Muncaster Mill Road Sidewalk, Mandatory Referral, MR2016012

A. Mandatory Referral 2016012, Muncaster Mill Road Sidewalk

Transmit the following comments to the Montgomery County Department of Transportation:

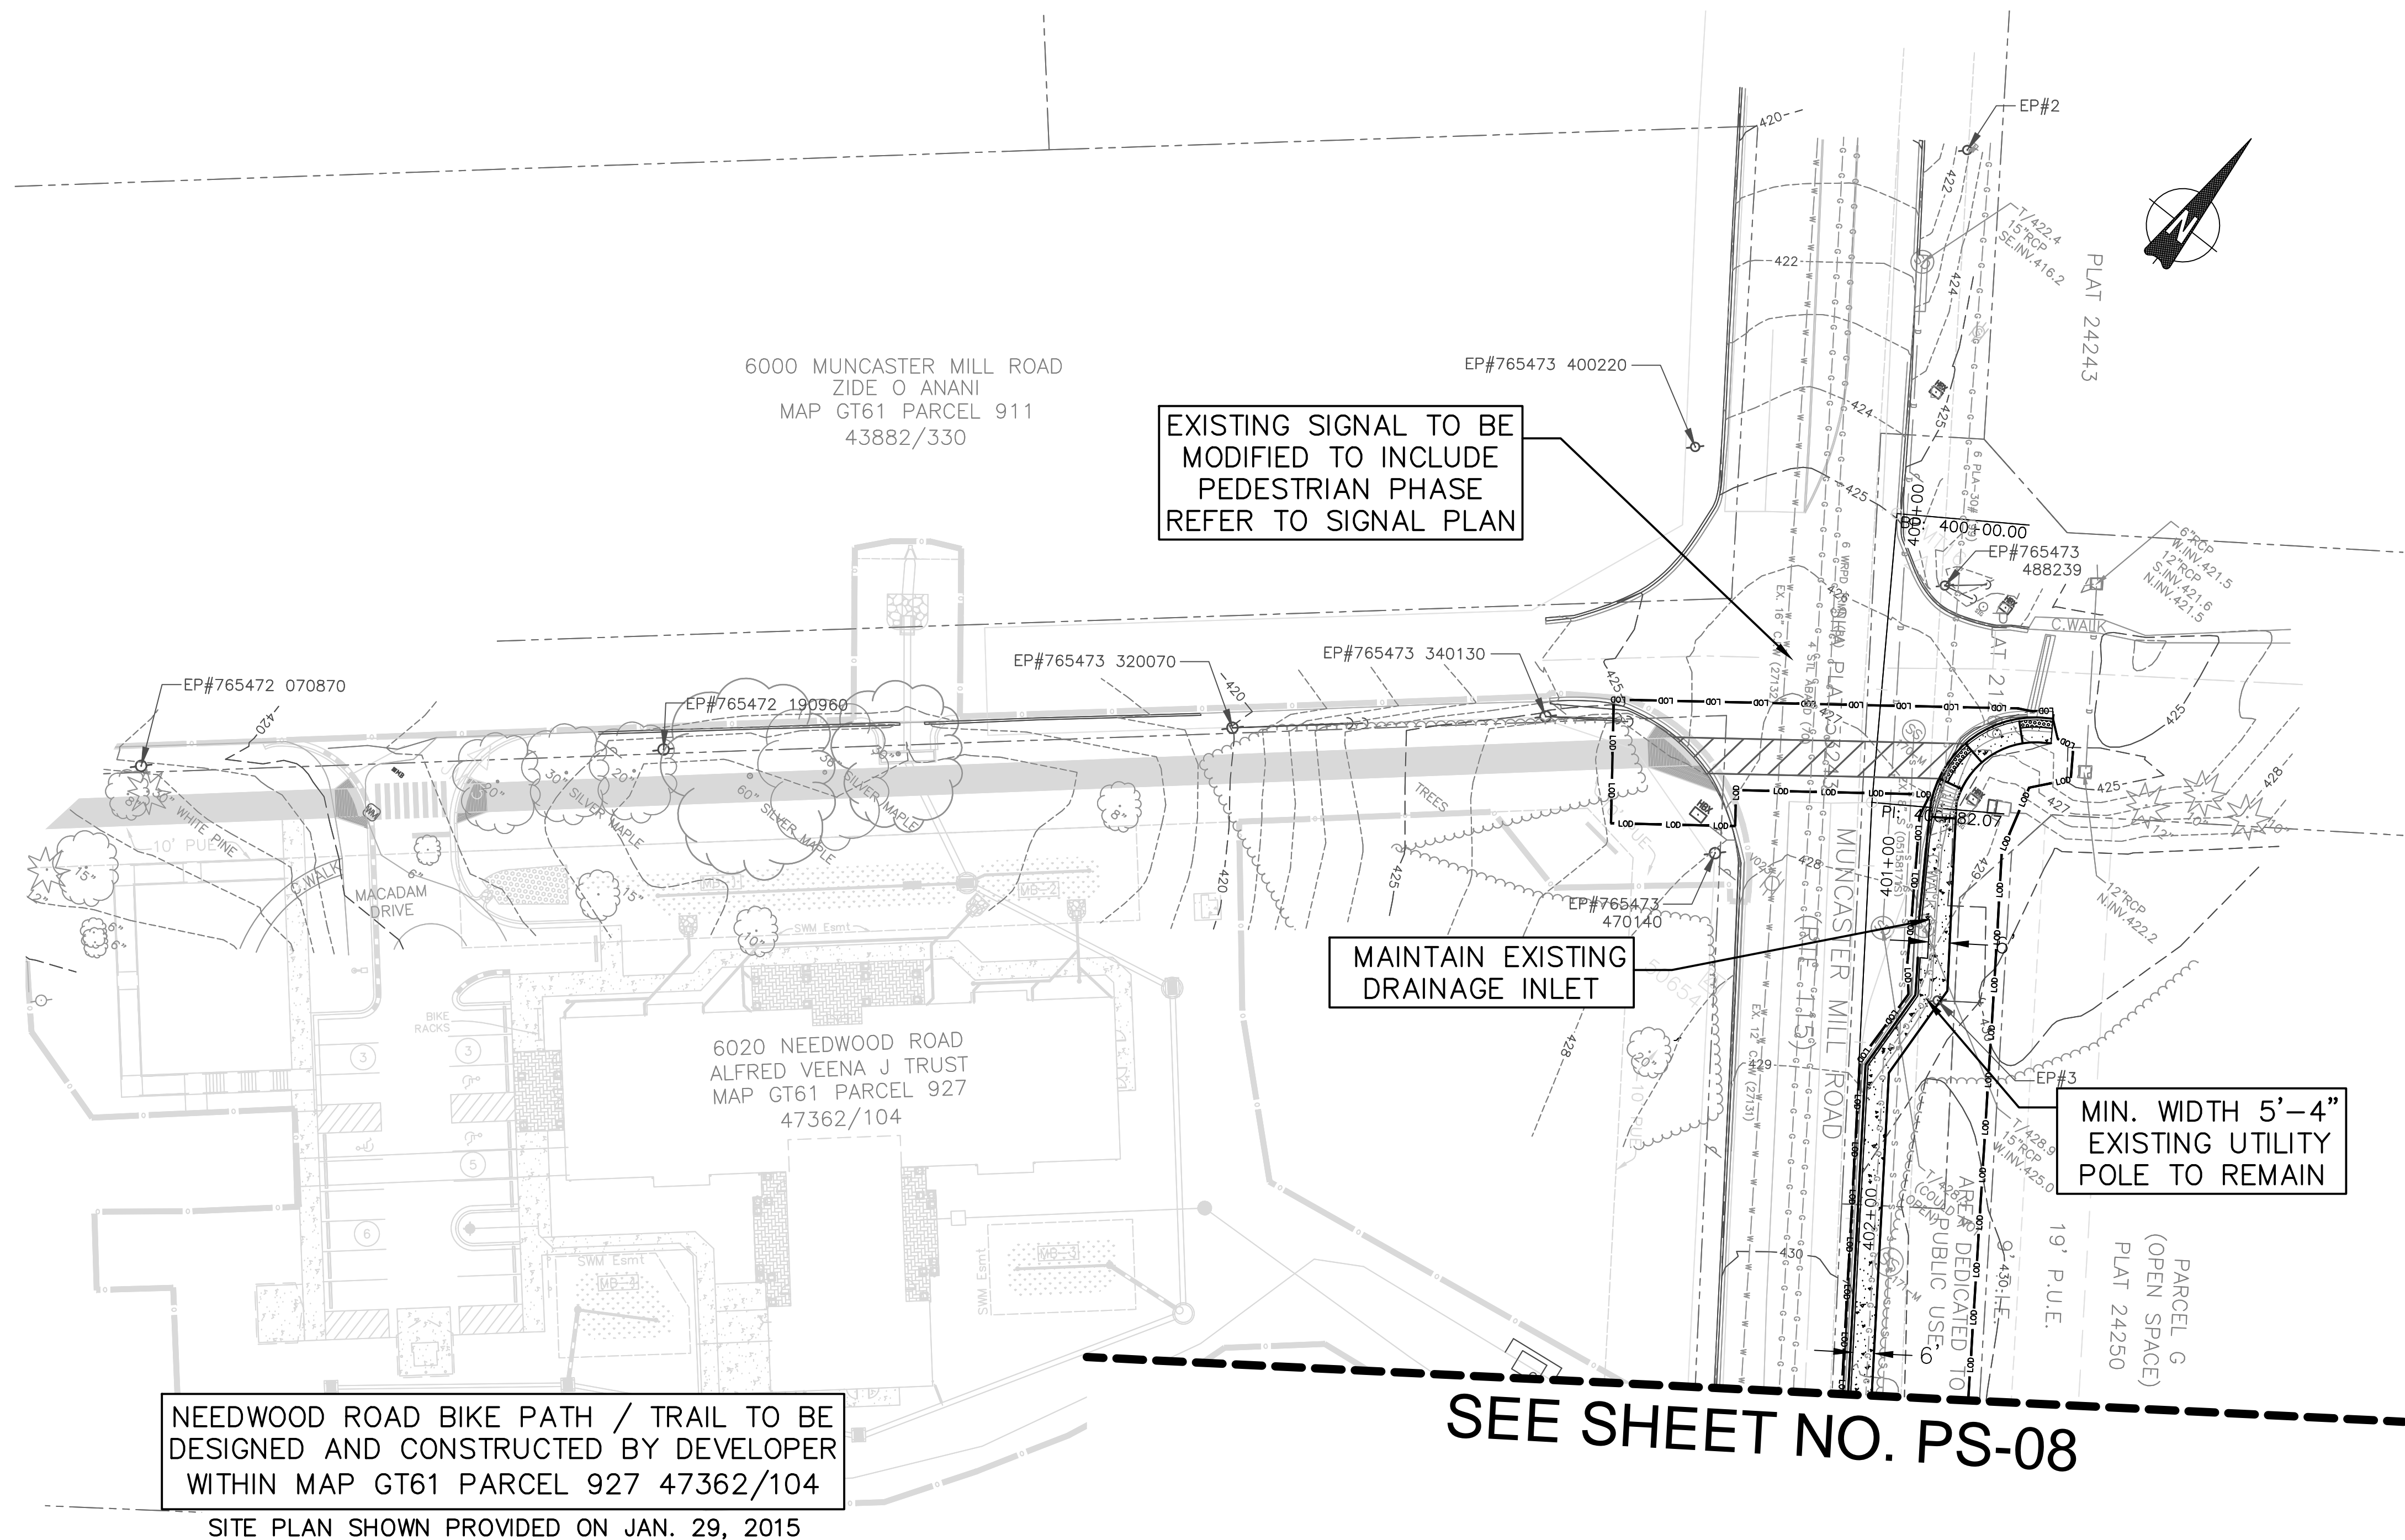
3. The sidewalk at the southeast corner of Needwood Road should be constructed behind the handicap ramp rather than through it so that waiting pedestrians are farther away from traffic.

5. Consider striping crosswalk for the north driveway, similar to what is proposed for the south driveway.
6. Consider constructing the lead sidewalk at the school on the north side of the driveway rather than the south side to:

- i. Provide a shorter crossing for pedestrians;
 - ii. Allow pedestrians to cross the driveway farther away from fast moving traffic; and
 - iii. Reduce impacts to the root zone of the 54-inch tree.

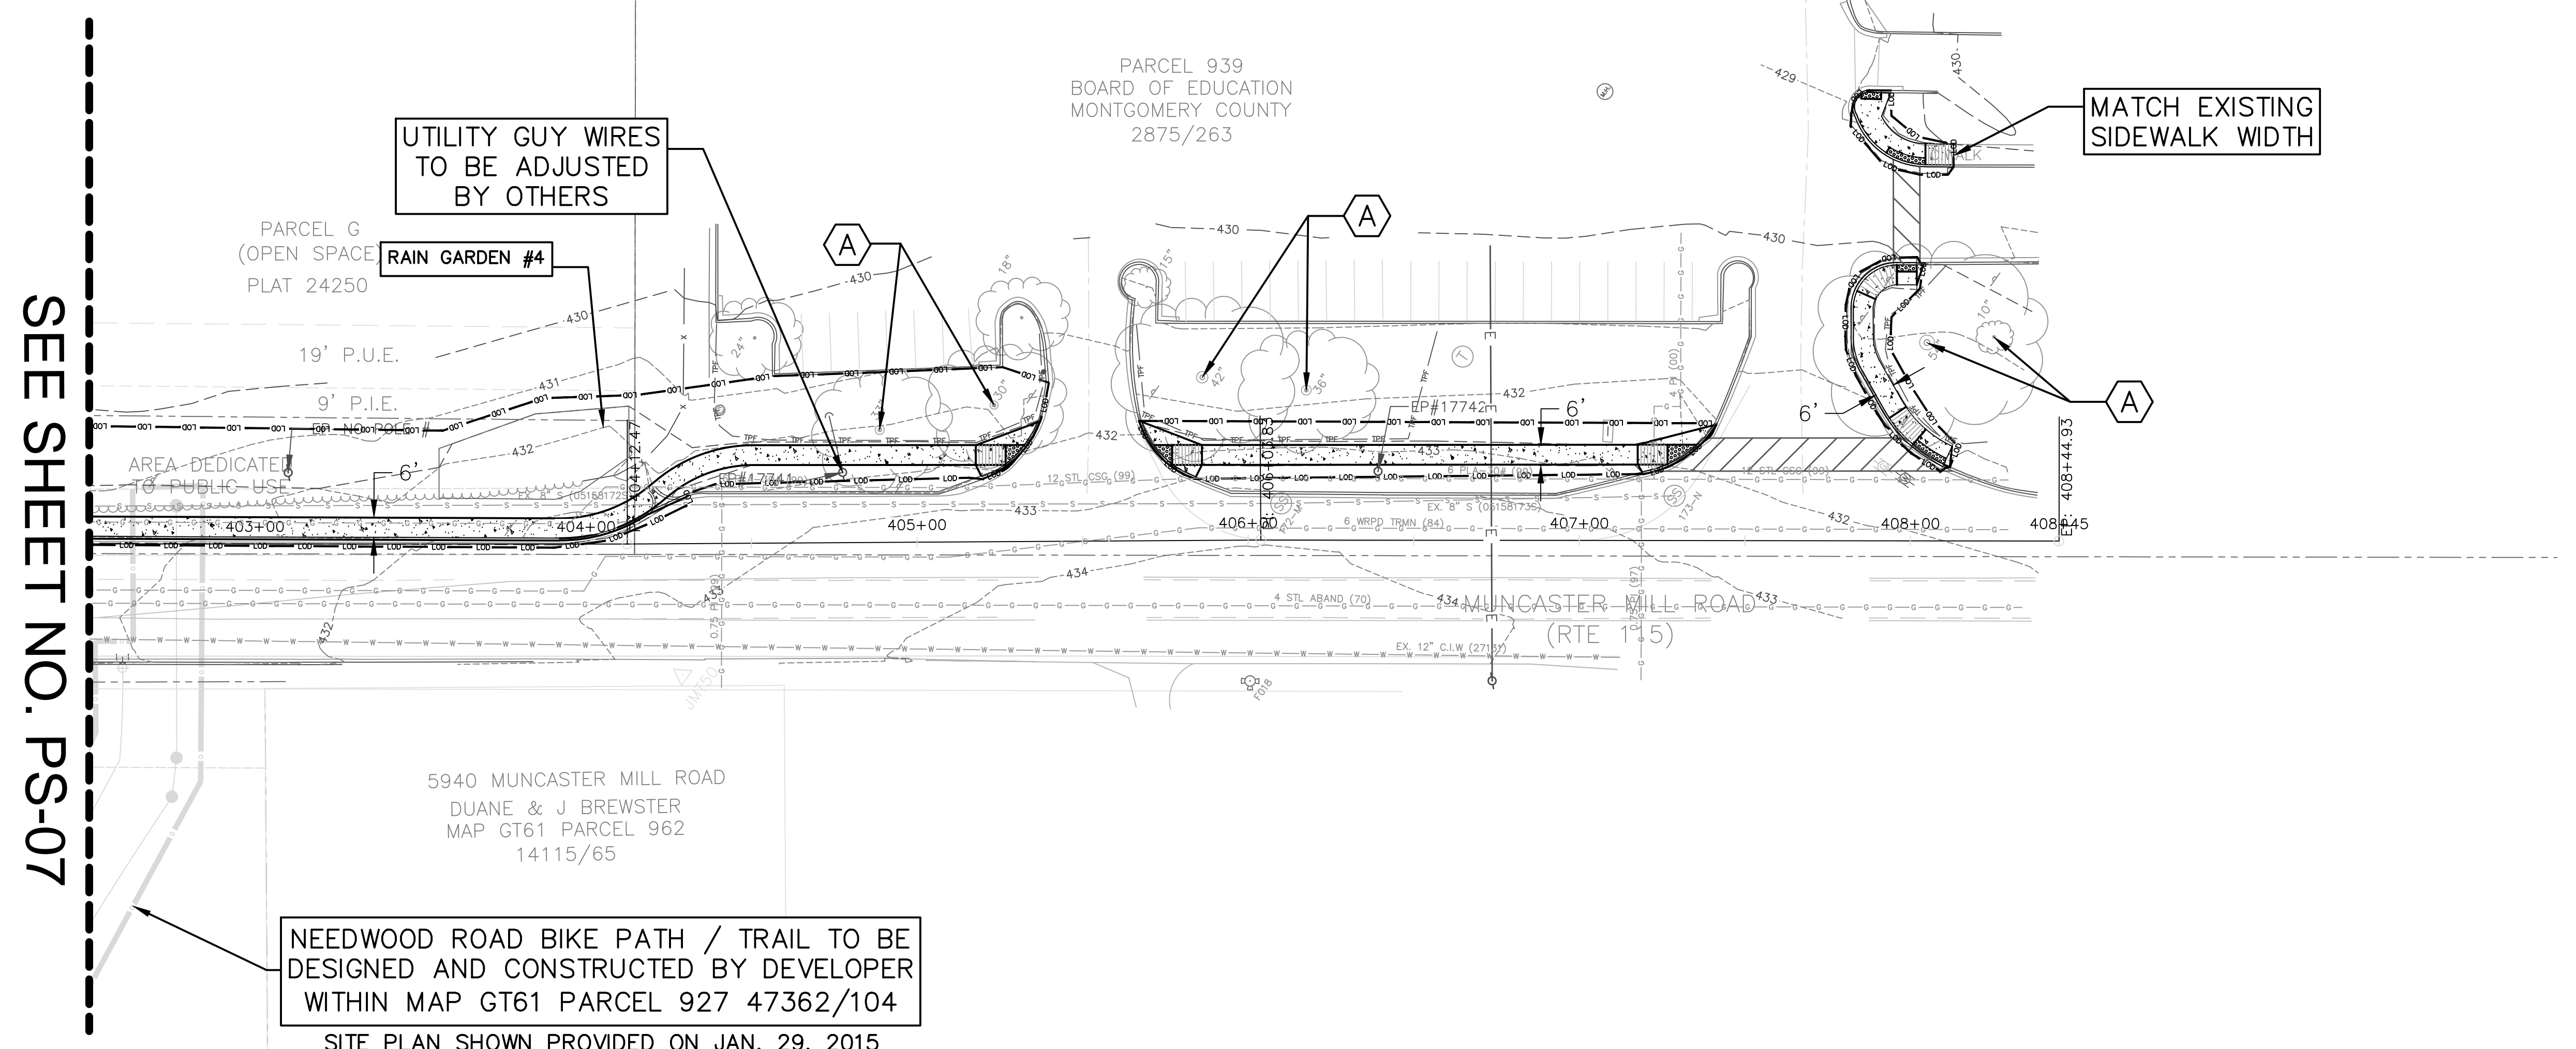
4. Since Muncaster Mill Road is an arterial with an average annual daily traffic volume of 19,462 vehicle trips (SHA 2014 data), the sidewalk in the northern half of the project should be offset from the curb for pedestrian safety and comfort, similar to what is proposed for the southern half of the project and to be consistent with County standards.
